**Additions and Renovations  
Platt Technical High School  
Milford, CT**

**ADDENDUM NO. 2**

July 29, 2019

**1 FIRST FLOOR PLUMBING BELOW SLAB - AREA B**  
 1/8" = 1'-0"

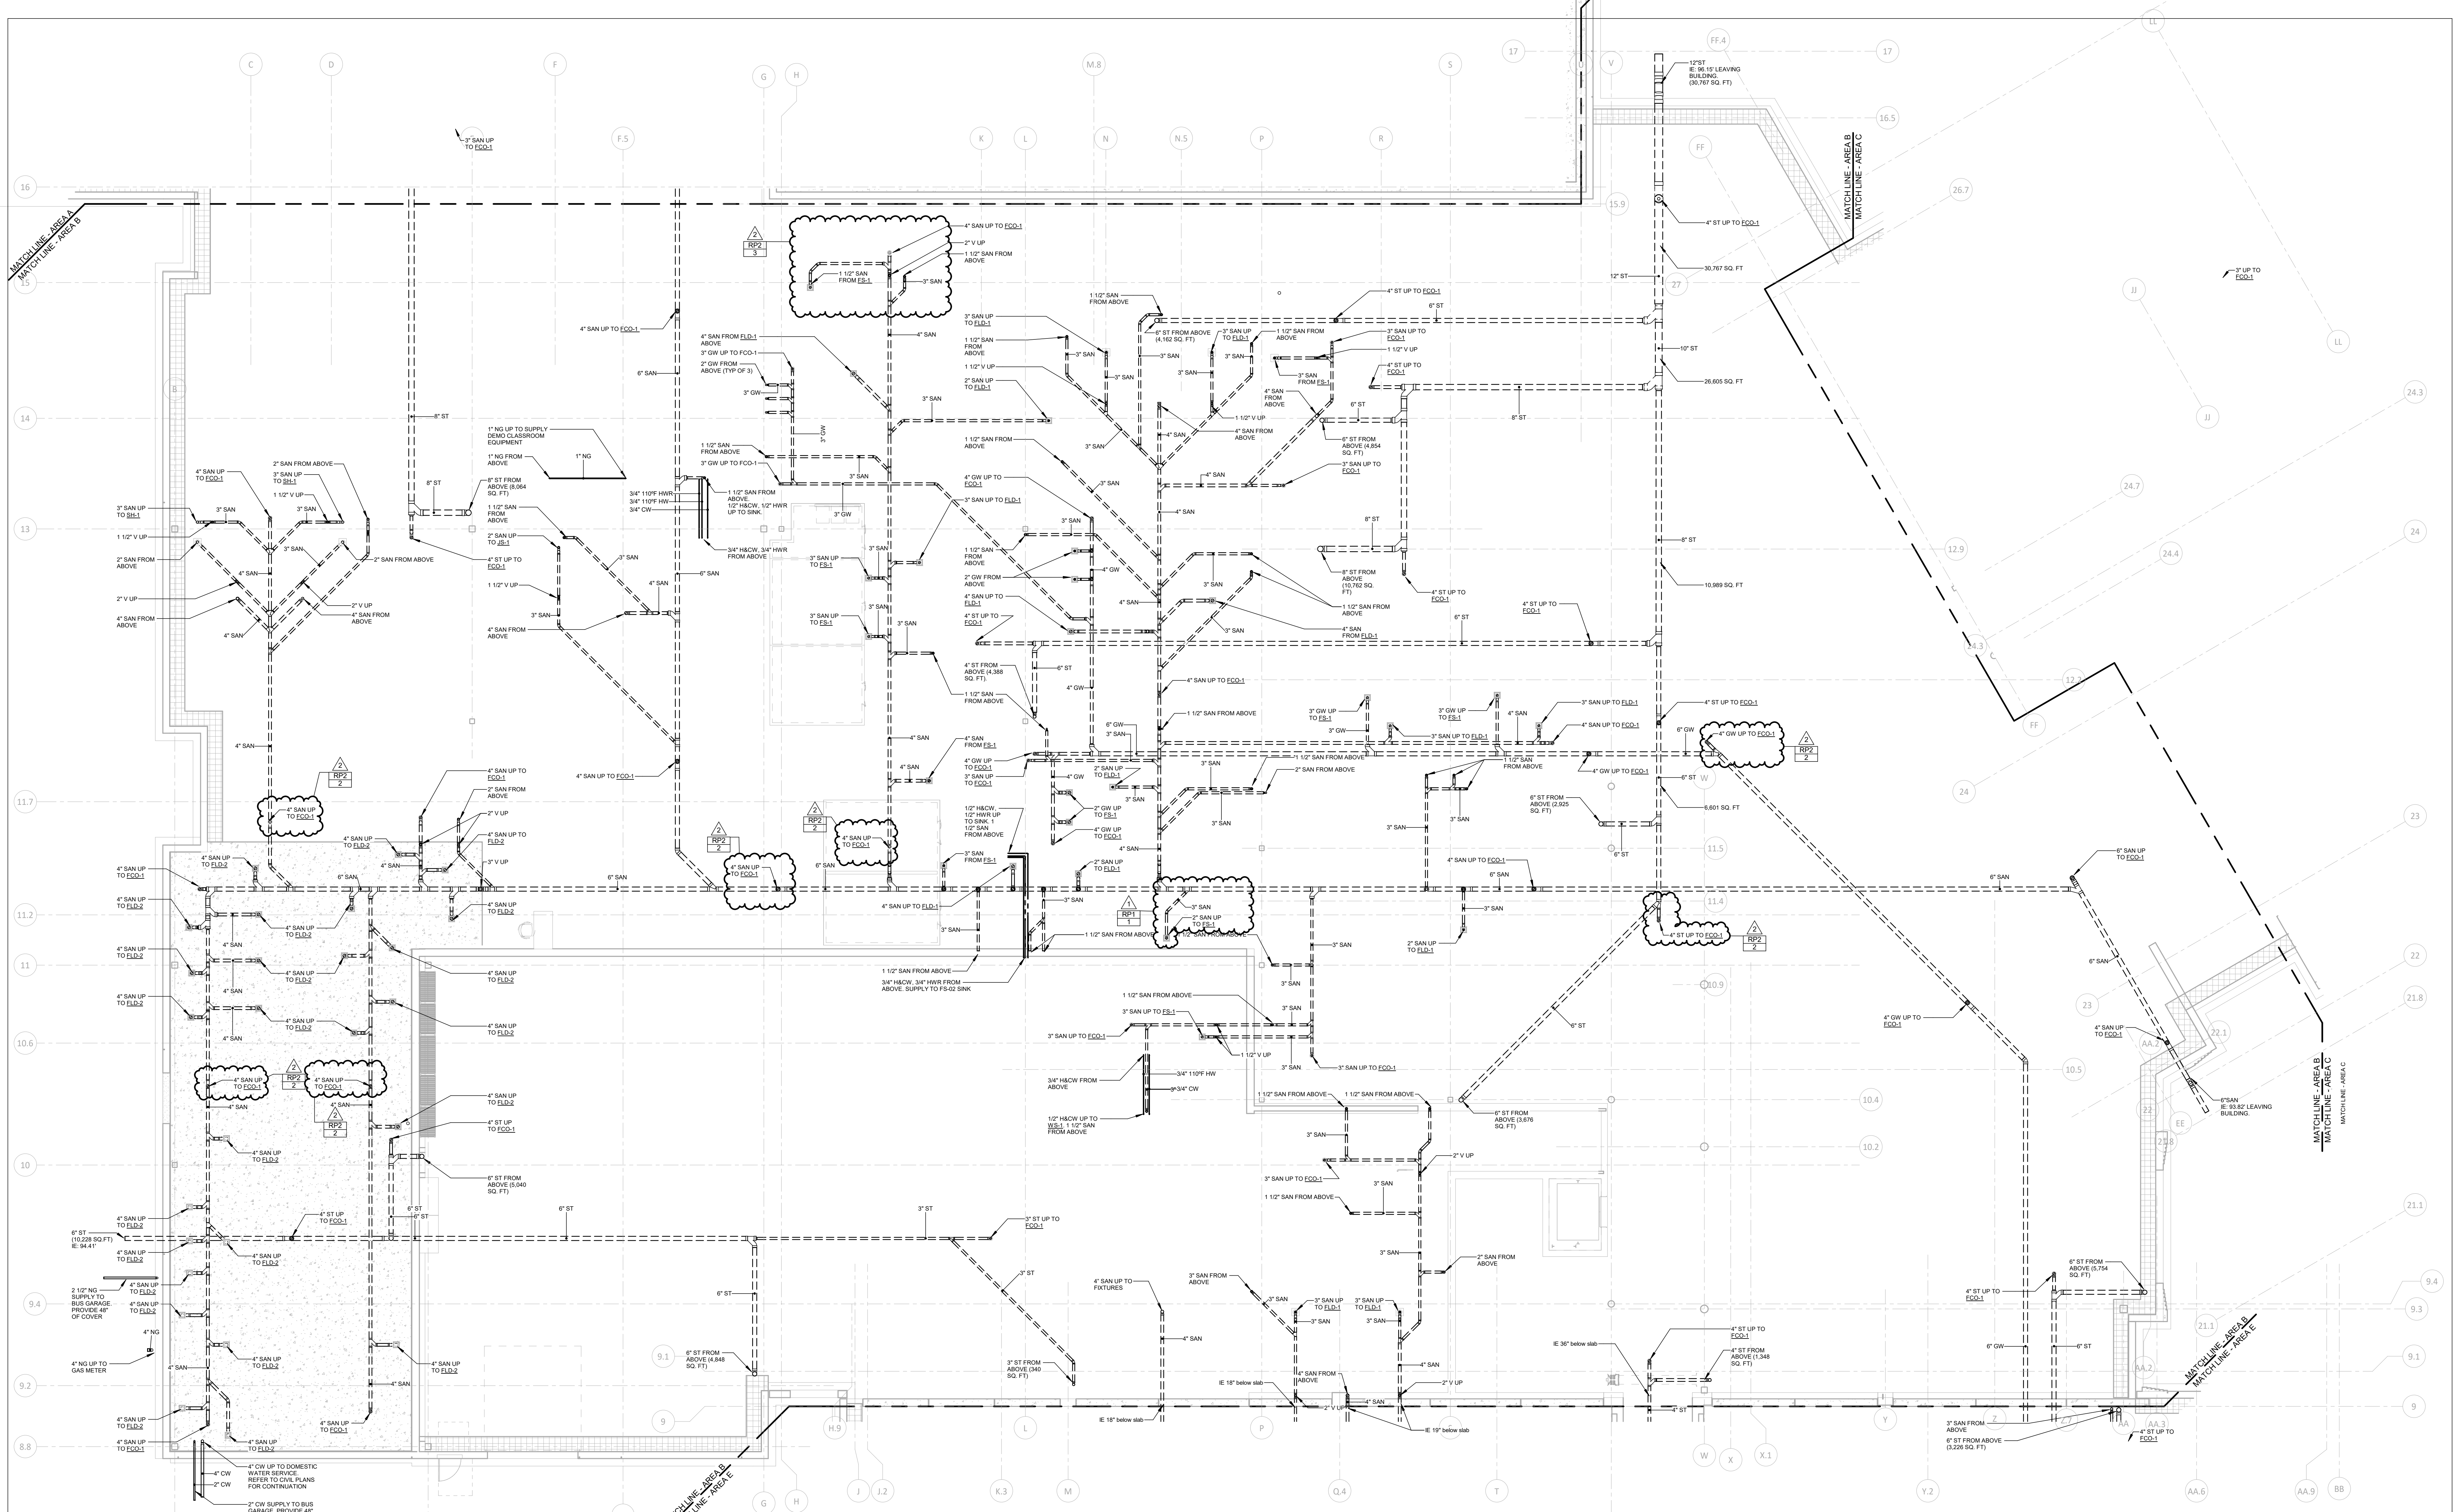
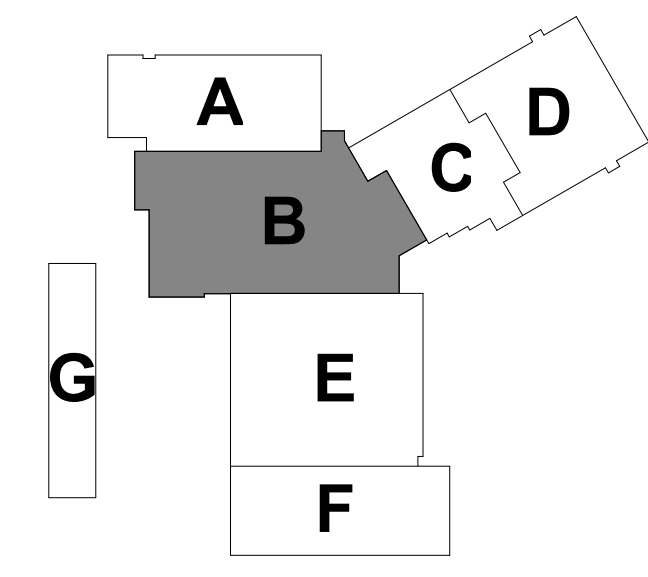
- ADD 2-020      DRAWING P1-1-UA – UNDERSLAB PLUMBING PLAN – AREA A**  
Added floor clean outs (FCO-1) and piping per Revision RP2-1.
- ADD 2-021      DRAWING P1-1-UB – UNDERSLAB PLUMBING PLAN – AREA B**  
Added floor clean outs (FCO-1) and piping per Revision RP2-2.  
Modified piping from FS-1 per Revision RP2-3.

1 FIRST FLOOR PLUMBING BELOW SLAB - AREA C  
 1/8" = 1'-0"  
 FFE: RP  
 REFER TO DRAWING P3-1-1 FOR PLUMBING LEGENDS.  
 REFER TO DRAWING P3-1-2 FOR SCHEDULES & FIXTURE CONNECTION SCHEDULE.  
 REFER TO DRAWINGS P4-1-1, P4-1-2 & P4-1-3 FOR PLUMBING DETAILS.

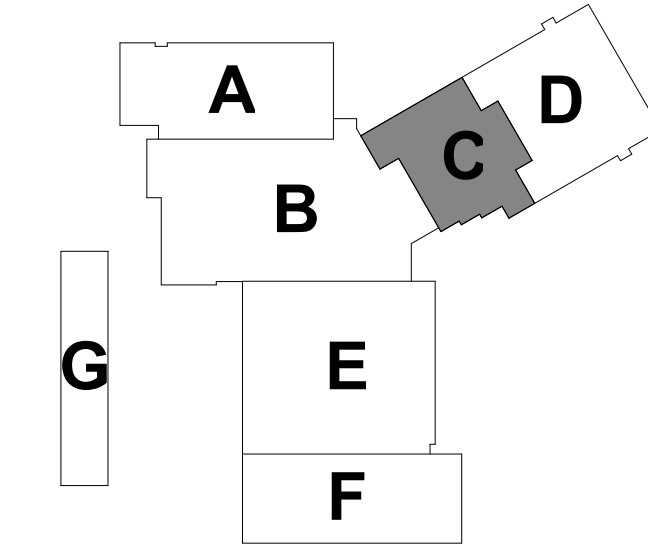
- ADD 2-022      DRAWING P1-1-UC – UNDERSLAB PLUMBING PLAN – AREA C**  
Added floor clean outs (FCO-1) and piping per Revision RP2-4
- ADD 2-023      DRAWING P1-1-UD – UNDERSLAB PLUMBING PLAN – AREA D**  
Added floor clean outs (FCO-1) and piping per Revision RP2-5  
Added floor clean outs (FCO-2) and piping per Revision RP2-6.  
Modified floor clean out tag (FCO to FCO-2) per Revision RP2-7.

**1 FIRST FLOOR PLUMBING BELOW SLAB - AREA E**  
 1/8" = 1'-0"  
 FFE: 0'  
 REFER TO DRAWING P3-1 FOR PLUMBING LEGENDS.  
 REFER TO DRAWING P3-2 FOR SCHEDULES & FIXTURE CONNECTION SCHEDULE.  
 REFER TO DRAWINGS P4-1, P4-1.2 & P4-1.3 FOR PLUMBING DETAILS.

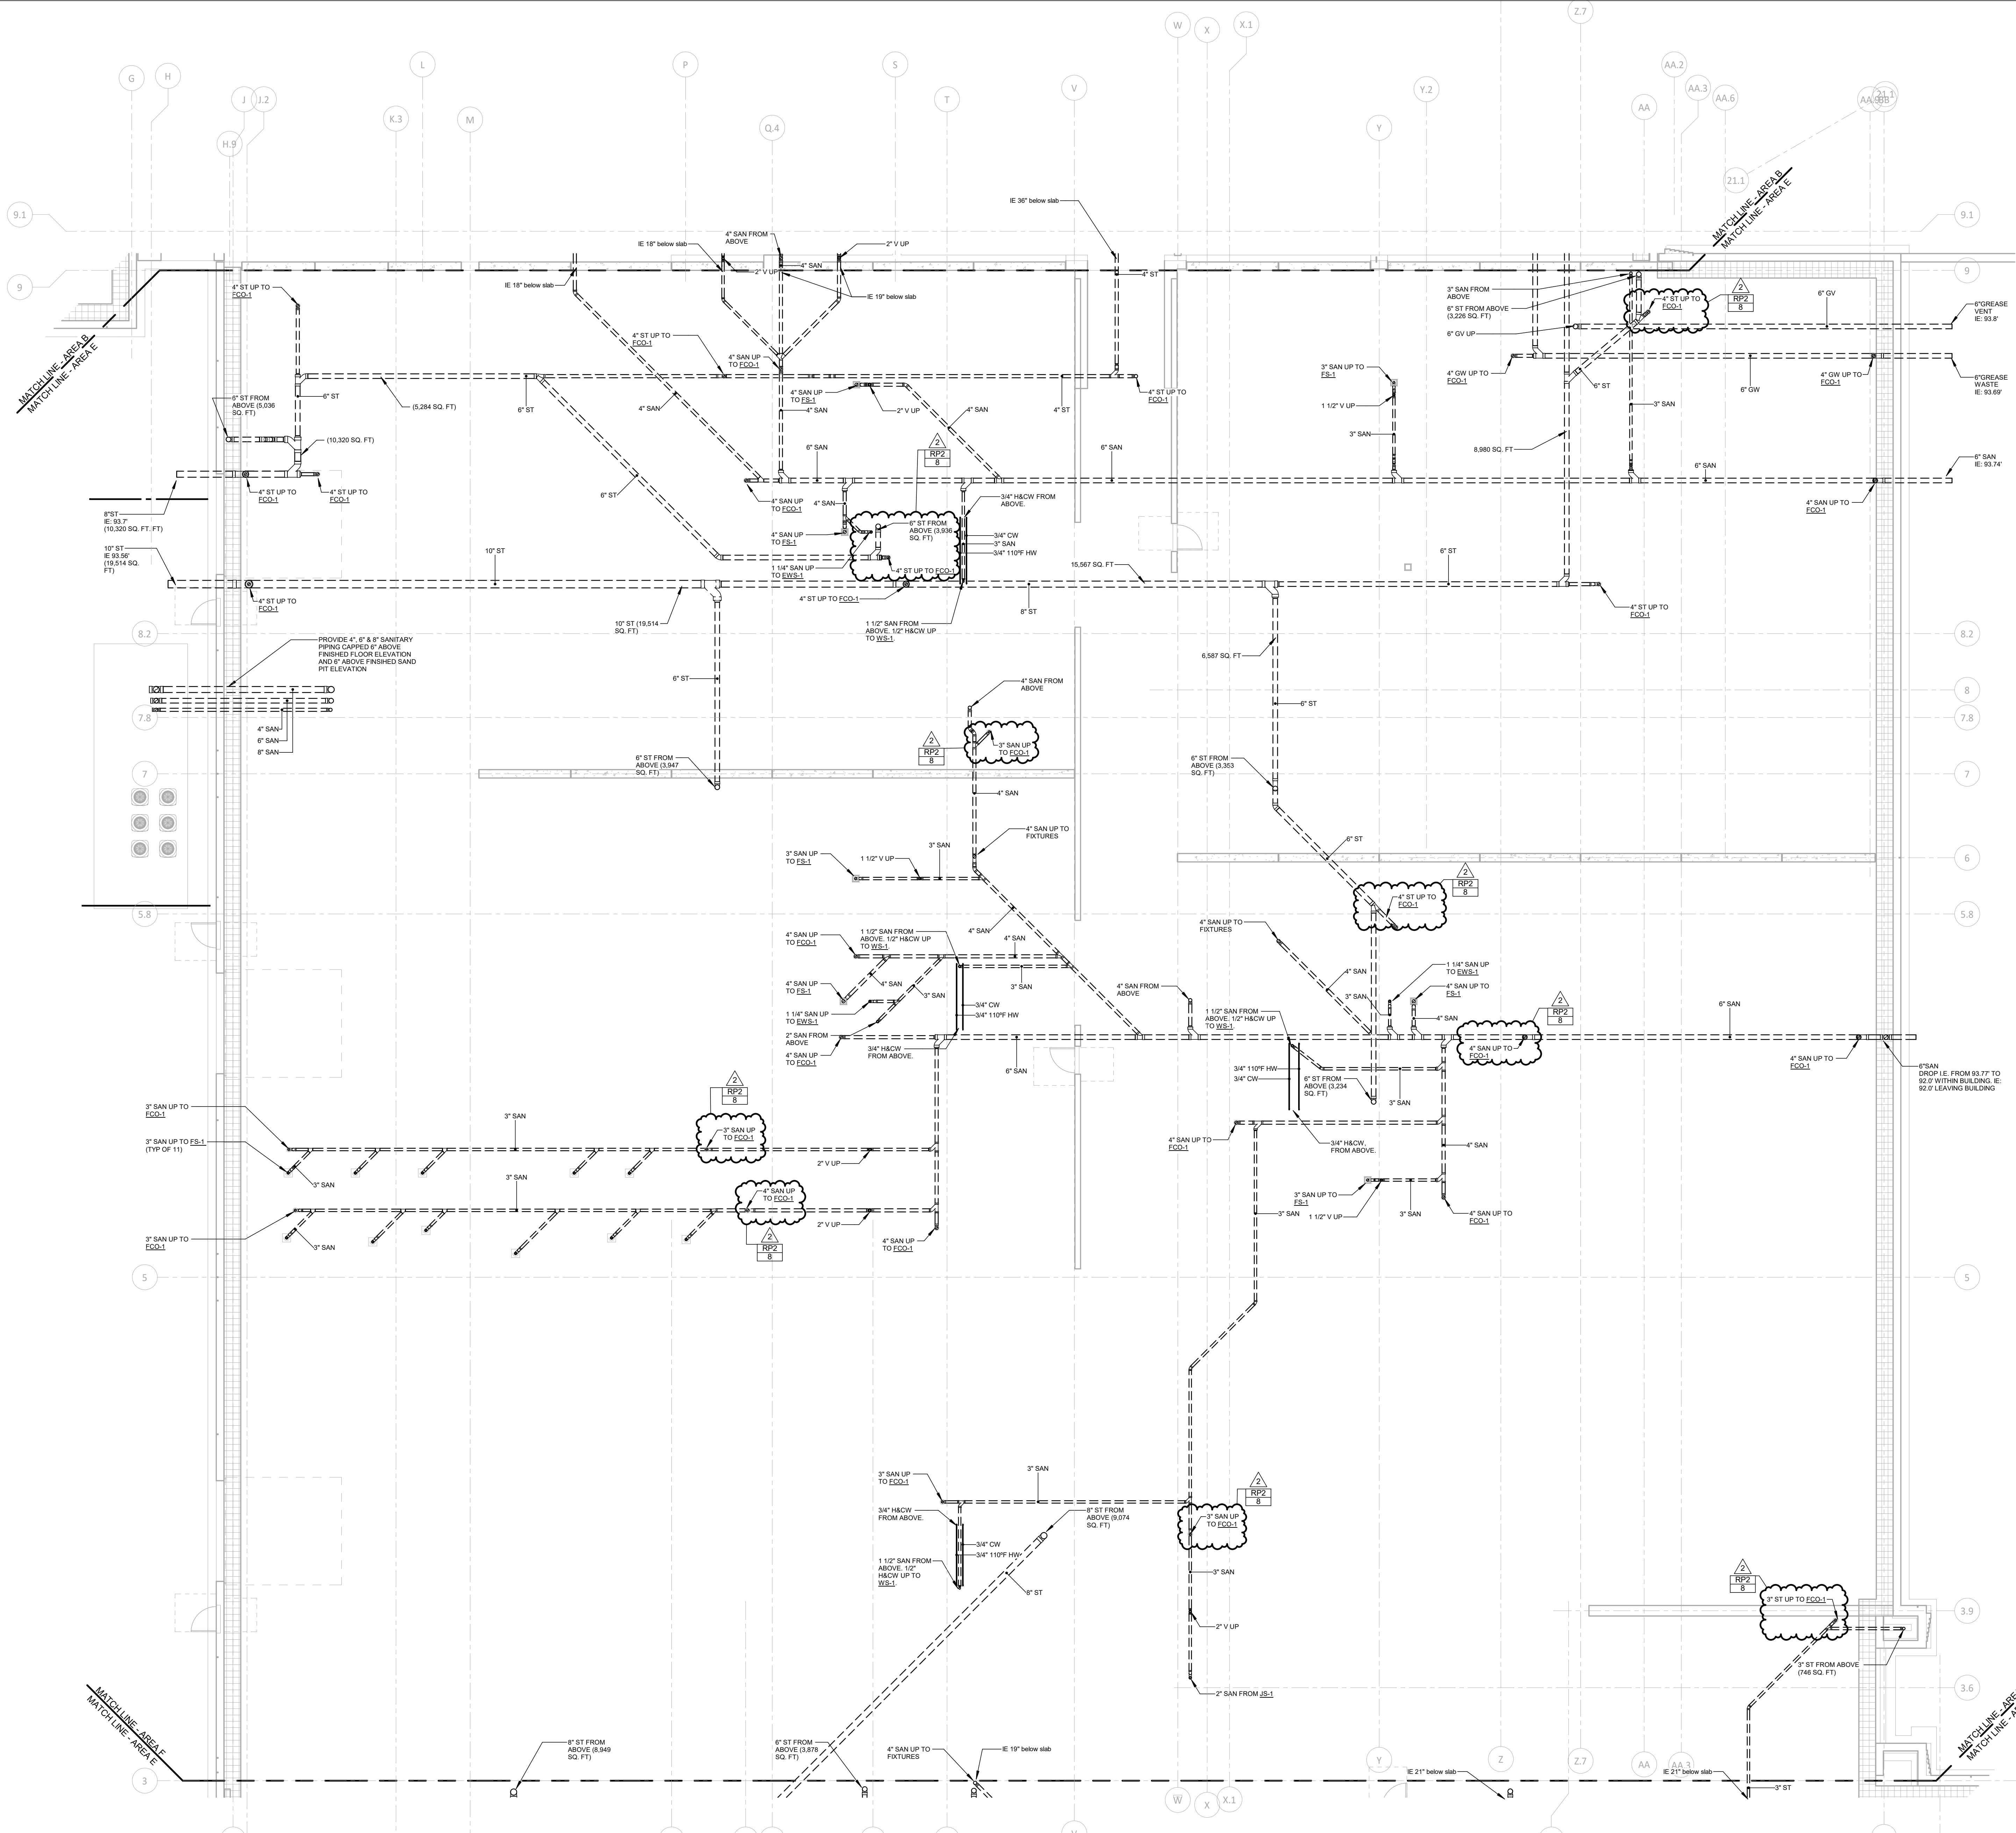
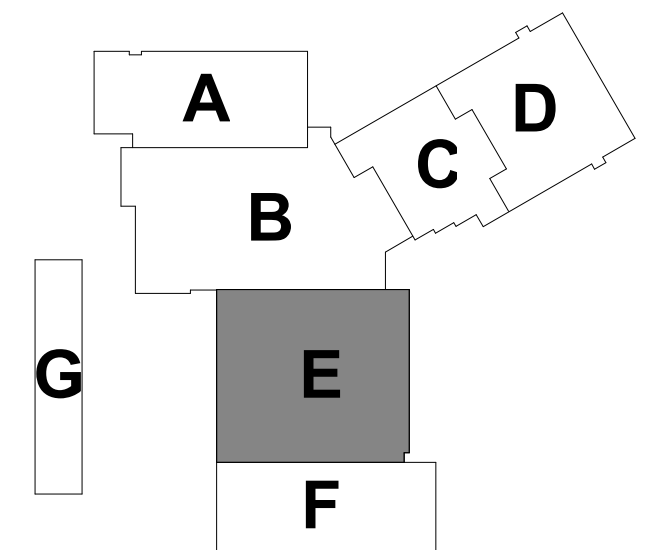
- ADD 2-024      DRAWING P1-1-UE – UNDERSLAB PLUMBING PLAN – AREA E**  
Added floor clean outs (FCO-1) and piping per Revision RP2-8.
- ADD 2-025      DRAWING P1-1-UF – UNDERSLAB PLUMBING PLAN – AREA F**  
Added floor clean outs (FCO-1) and piping per Revision RP2-9.  
Added floor clean out tag (FCO-1) per Revision RP2-10.
